W3F1-98-0184
A4.05
PR

Subject: Waterford 3 SES
Docket No. 50-382
License No. NPF-38
Request for Additional Information Regarding
Response to Generic Letter 96-06

**Response to the Request for Additional Information
Regarding Response to Generic Letter 96-06 for
Waterford Unit 3 (TAC NO. M96883)**

W3F1-98-0184
 Figure B

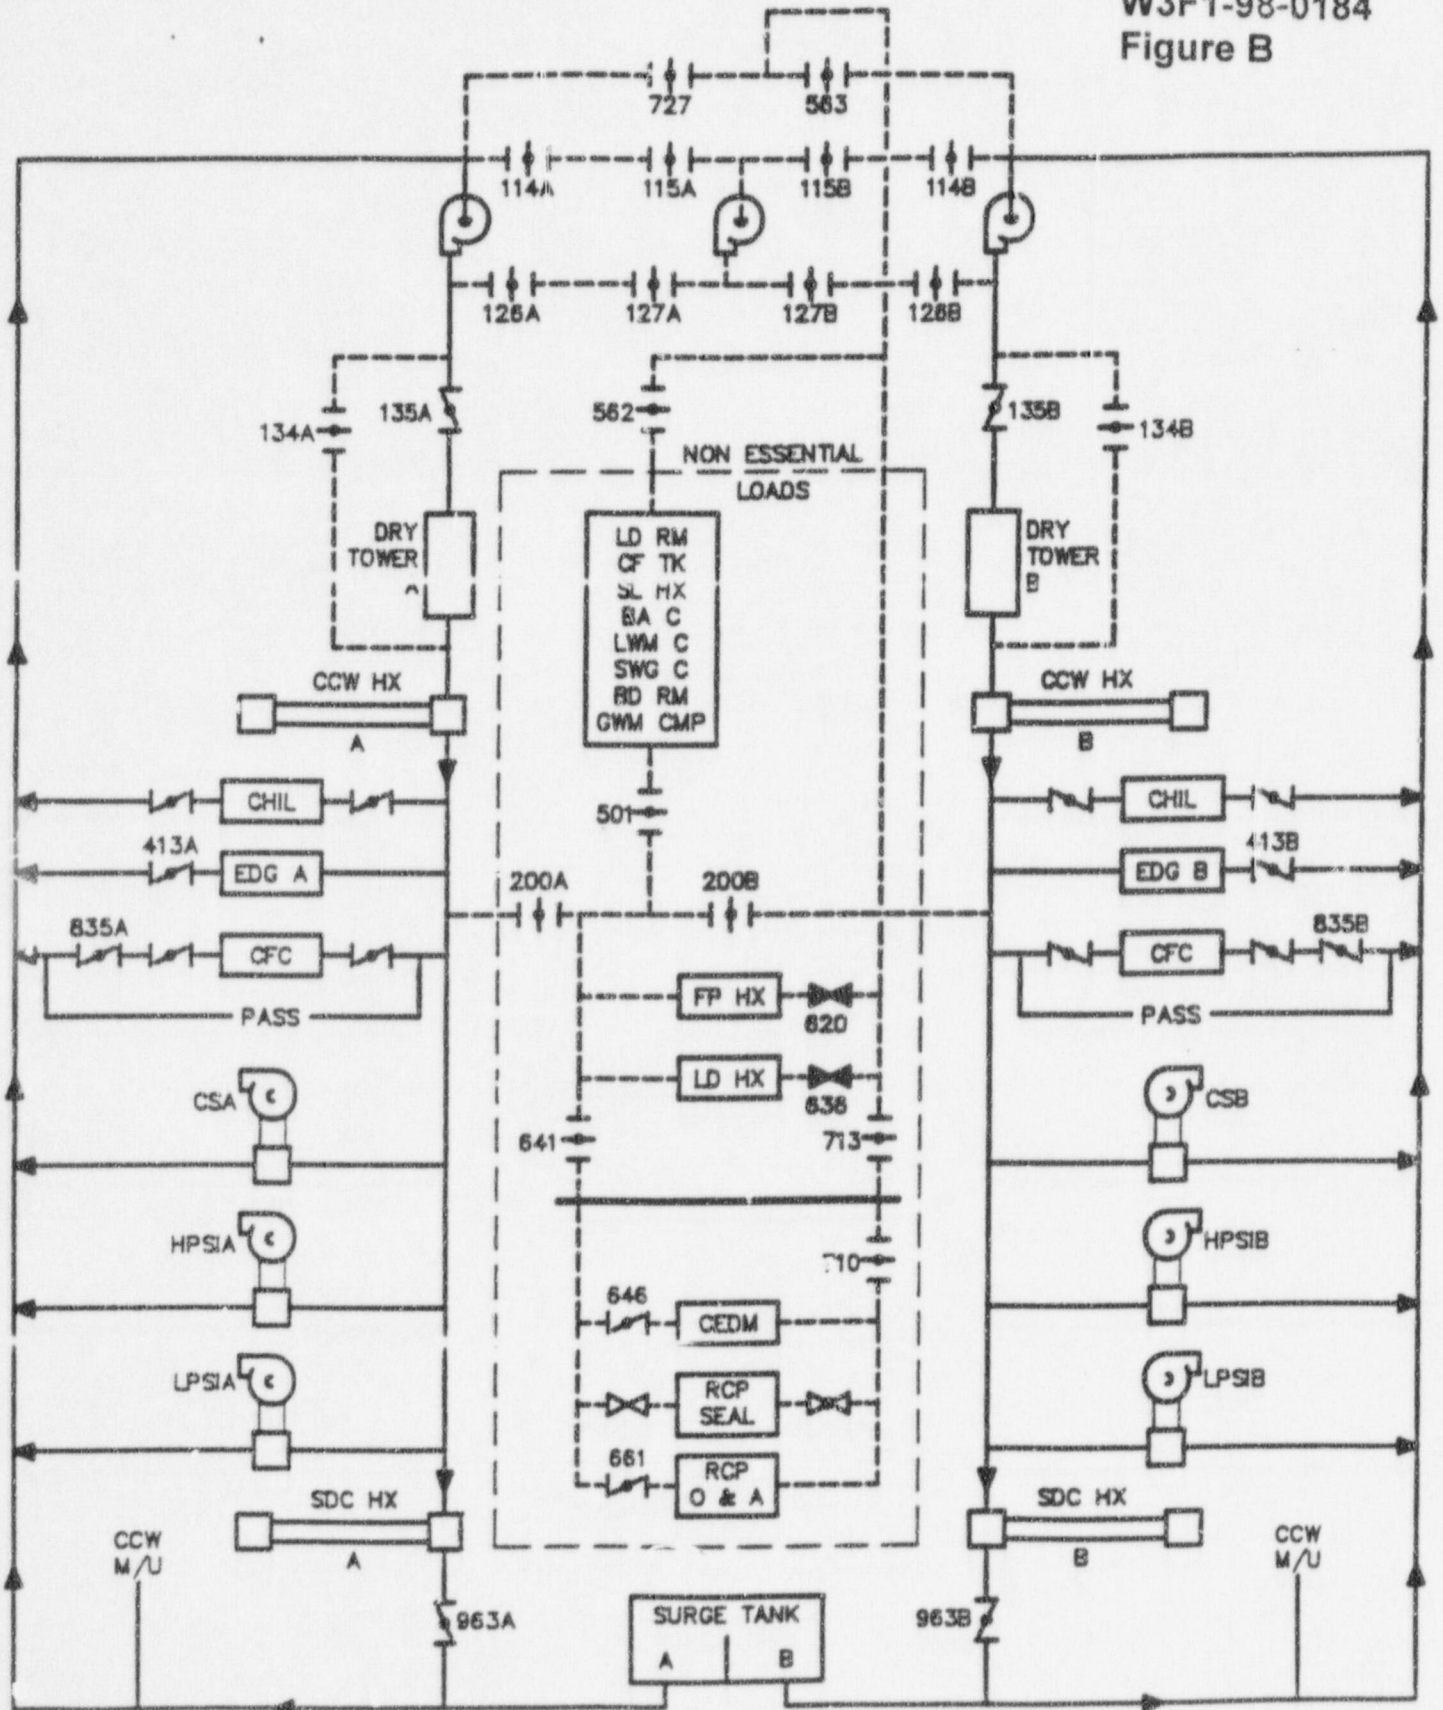
Provide a simplified diagram of the affected system, showing major components, active components, relative elevations, lengths of piping runs, and the location of any orifices and flow restrictions.

A diagram of the affected system is shown in Figure A. The CCW piping detailed is the return piping from the "A" train CFCs (3C-SA and 3A-SA) located at Floor Elevation +21'. Note that the top of the CFC extends to approximately the +34.5' Elevation. The "B" train CFCs are located lower in containment (Floor Elevation -4') which will increase the saturation pressure for the CCW water inside. A simplified diagram of the entire CCW system is shown in Figure B.
